CITY OF OPELIKA
HISTORIC PRESERVATION COMMISSION
July 9, 2026
4:30 p.m.
Meeting Chambers at Opelika Municipal Courtroom
300 MLK Boulevard

Agenda Item #: 1
Meeting Date: 07/09/2026
Action Requested: COA: Add Front Porch, Replace Windows, Add Overhang
Location of Property: 714 Ave D; Geneva Historic District
Petitioner: Alexander Bell

Agenda Item #: 2
Meeting Date: 07/09/2026
Action Requested: COA: Replace Double Entry Doors
Location of Property: 830 N. Railroad Ave; Downtown Historic District
Petitioner: Scott Brown

Side of house facing S. 8th St

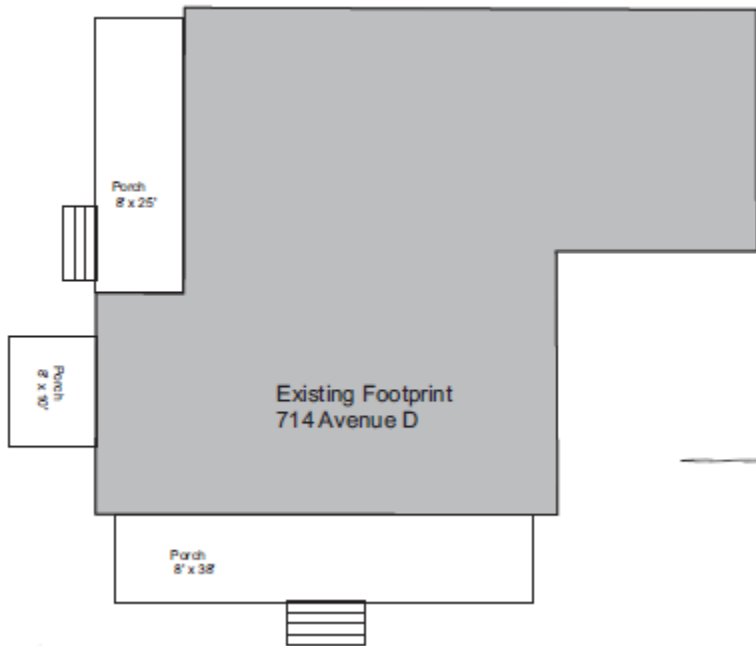
1. Add 40' x 8' front porch to match the design and materials of the side porch including 6"x6" posts, custom wood baluster, wood steps. Decking will be composite with wood grain look.
2. Replace 3 to 4 windows to include two basement casement windows and the right 2nd story casement window due to lower casement rail rot. The fourth window has a failed seal. All windows are 1/1. Original windows are wood and will be replaced with wood windows.
3. Add wood awnings with decorative wood brackets above garage and 2nd floor entry doors to match design of the house. The roof will be 5V crimped metal.
4. Additional work includes finishing the handrail and replacing the front step balusters. These are custom cut items based on the baluster pattern inside Trinity Methodist Church.

1. Staff recommends approval of the front porch addition matching the side porch in material and design.
2. Staff recommends approval of Anderson wood clad casement windows for this home is a noncontributing structure.
3. Staff recommends approval of adding awnings above the garage and 2nd floor entry doors to match design of house.
4. Maintenance of items do not require Staff or Commission approval.

MMI DOOR 72-in x 80-in x 6-9/16-in Fiberglass Right-hand inswing Primed Prehung Residential Insulating core Front Door

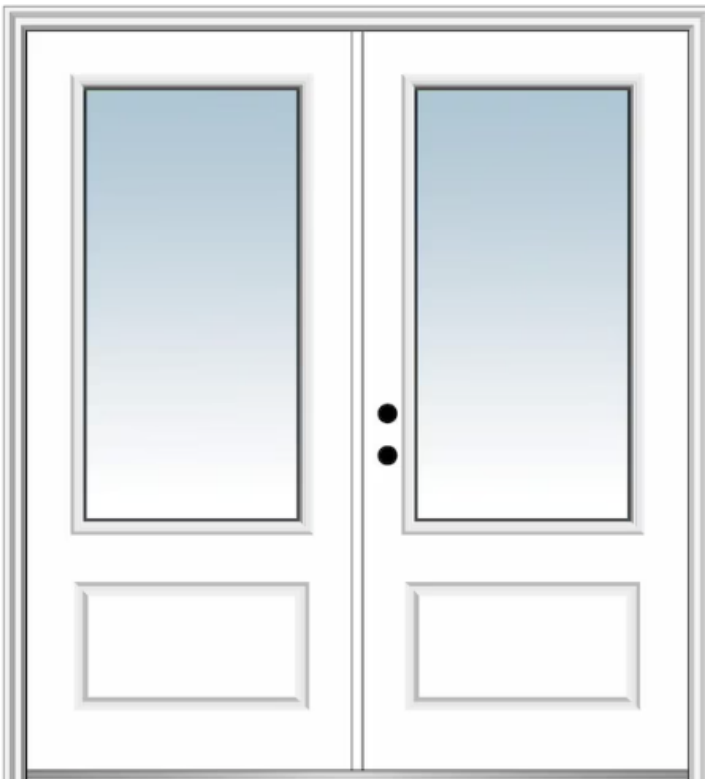
1. Replace two sets of double metal doors with double 34 lite fiberglass insulating core doors on the front. Doors will be painted.

1. *Staff recommends approval of fiberglass doors to replace current metal door units on this noncontributing structure.*
